**DOCKET 50-255 - LICENSE DPR-20 - PALISADES PLANT  
TECHNICAL SPECIFICATION CHANGE REQUEST  
SPENT FUEL POOL BORON CONCENTRATION**

TECHNICAL SPECIFICATION CHANGE REQUEST  
SPENT FUEL POOL BORON CONCENTRATION

**ENCLOSURE 1  
REQUEST FOR CHANGE TO THE TECHNICAL SPECIFICATIONS  
SPENT FUEL POOL BORON CONCENTRATION**

**TECHNICAL SPECIFICATIONS CHANGE REQUEST  
SPENT FUEL POOL BORON CONCENTRATION**

Figure 4.3-1 (page 1 of 1)  
New Fuel Storage Rack Arrangement

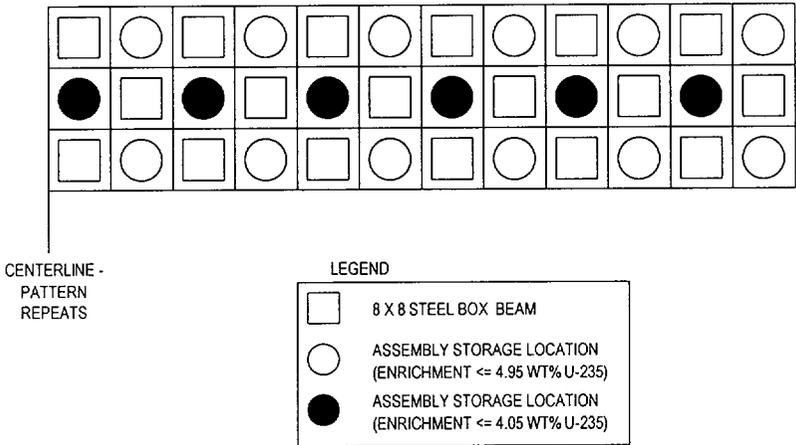
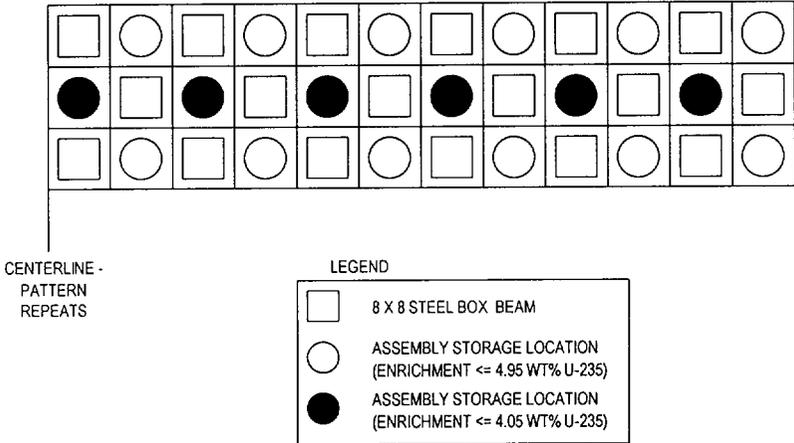
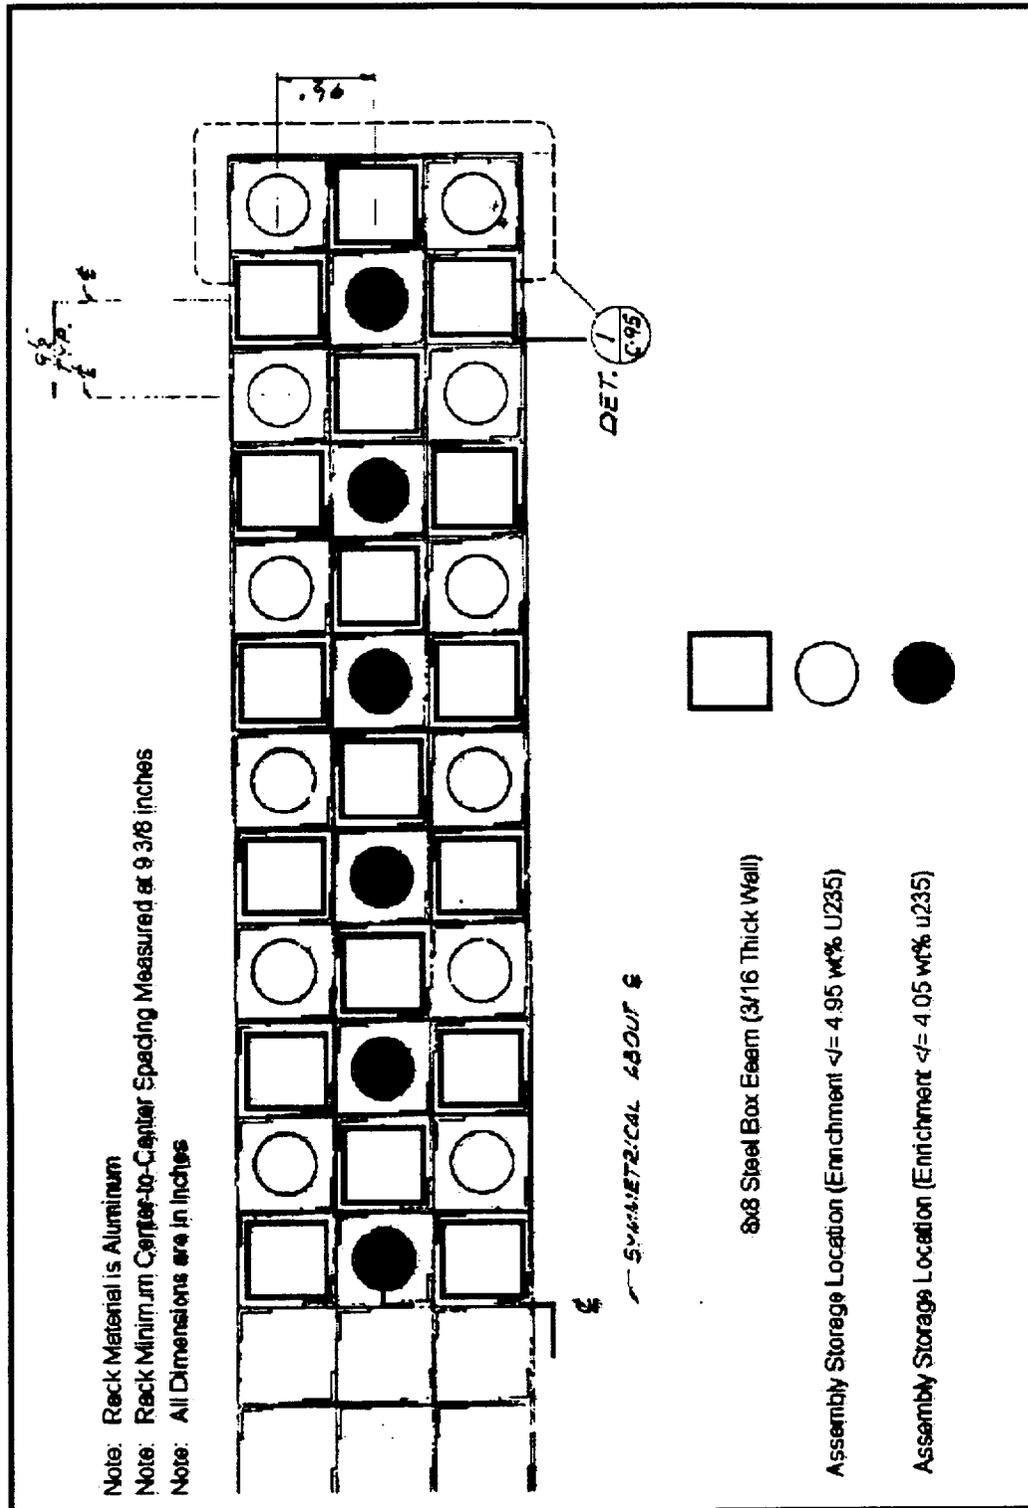
*“Twenty-four unirradiated fuel assemblies having a maximum planar average U-235 enrichment of 4.95 weight percent, and stored in accordance with the pattern shown in Figure 4.3.-1, or*

*Thirty-six unirradiated fuel assemblies having a maximum planar average U-235 enrichment of 4.05 weight percent, and stored in accordance with the pattern shown in Figure. 4.3.-1.”*

8. Delete existing Specification 4.3.1.3.c
9. Renumber existing Specification 4.3.1.3d to 4.3.1.3c
10. Add a new figure, Figure 4.3-1; Figure 3 from EA-SFP-99-03.

- 4.3.1.3 The new fuel storage racks are designed and shall be maintained with:
- a. Twenty four unirradiated fuel assemblies having a maximum planar average U-235 enrichment of 4.95 weight percent, and stored in accordance with the pattern shown in Figure 4.3-1, or

Thirty six unirradiated fuel assemblies having a maximum planar average U-235 enrichment of 4.05 weight percent, and stored in accordance with the pattern shown in Figure 4.3-1;
  - b.  $K_{\text{eff}} \leq 0.95$  when flooded with either full density or low density (optimum moderation) water including allowances for uncertainties as described in Section 9.11 of the FSAR.

Figure 9 Region II Burnup Curves.

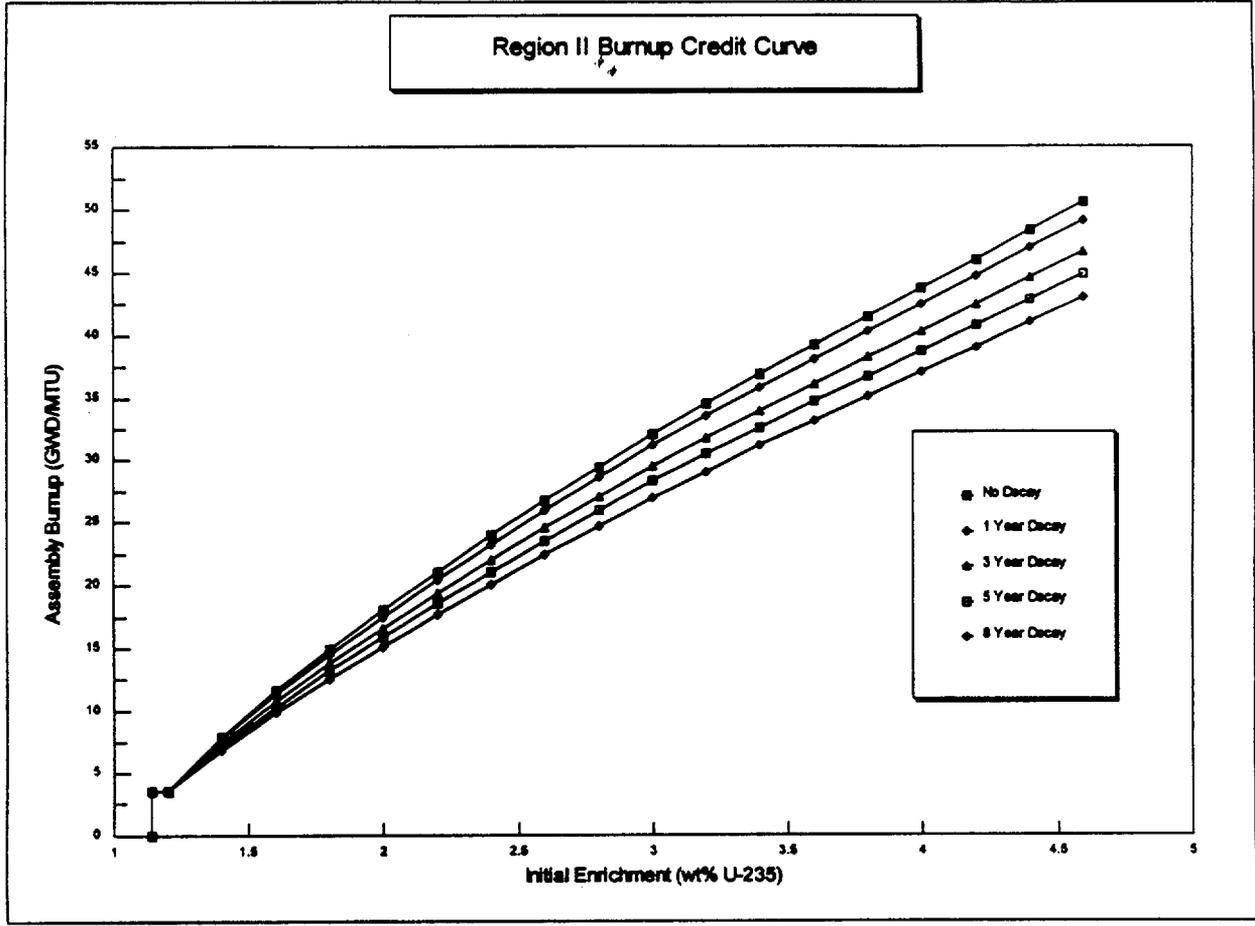
3. Replace Table 3.7.16-1 with Table 4 from EA-SFP-99-03.

The curves presented in Figure 9 are used to determine the eligibility of assemblies for storage in the Region II racks. They are developed to ensure that  $k_{95/95-No Boron}$  remains below 1.0 (subcritical). Assemblies are classified by their maximum average planar initial enrichment in wt%  $^{235}\text{U}$ . If an assembly has an average

Table 4 provides the data used to create Figure 9. It is acceptable to linearly interpolate between points to determine the required burnup for assemblies with initial enrichments not explicitly stated [33]. In addition, consideration of a 10% uncertainty in assembly burnup records is accounted for in the development of  $k_{95/95-850\text{ppm}}$ . It is therefore, NOT necessary to reduce stated burnup by a measurement uncertainty up to 10% when evaluating an assembly against the curves.
